LETTER AND COMMENTS TO DRAFT FINAL FACILITY INVESTIGATION WORK PLAN
ADDENDUM SITES 1, 3 AND 4 NAS CORPUS CHRISTI TX
7/5/1996
ENSAFE

**Re: Revisions to Draft-Final Facility Investigation Work Plan Addendum,
Installation Restoration Sites 1, 3, and 4, NAS Corpus Christi**

FIGURE 2-11
SITES 1, 3, AND 4
PROPOSED DPT
SAMPLE LOCATIONS
NAS CORPUS CHRISTI

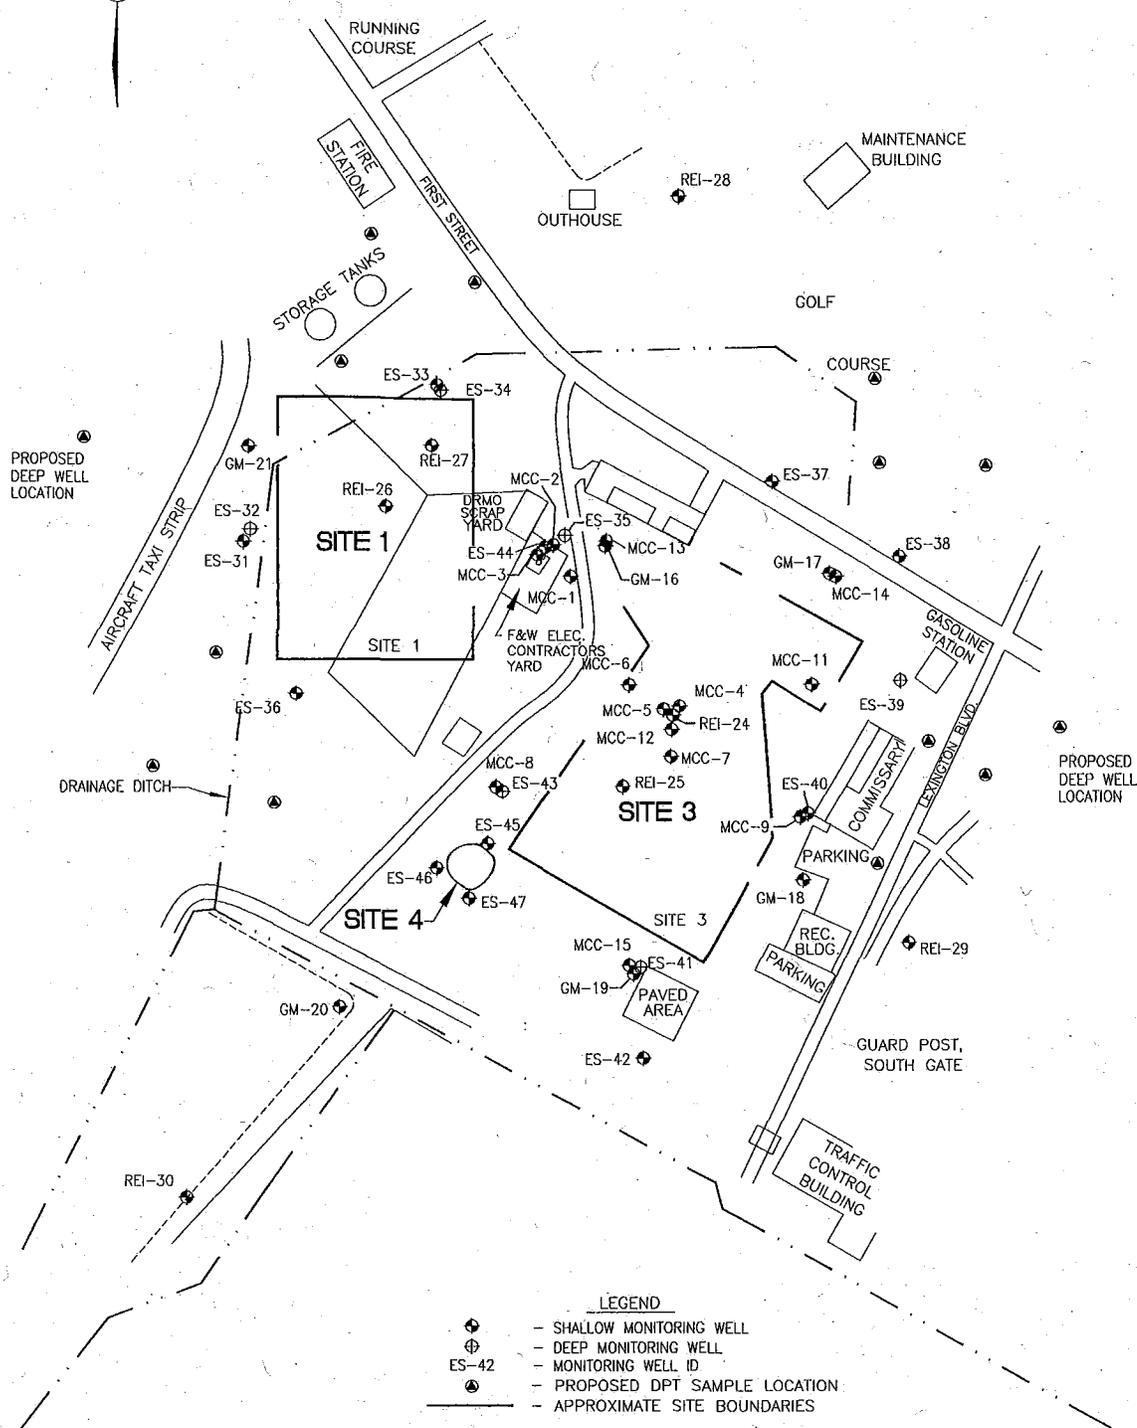
1. Figure 2-11 has been revised to reflect the new DPT locations agreed upon at our June 13, 1996 meeting. A copy of the revised figure is attached.
2. Page 15 of the addendum should be revised to reflect that DPT groundwater samples will not be analyzed for metals. This change is being made because it is believed that the DPT metals results will not be comparable with the metals results which will be obtained from the existing monitoring wells. This is due to the fact that the existing wells will be sampled using low-flow or micropurging sampling techniques.
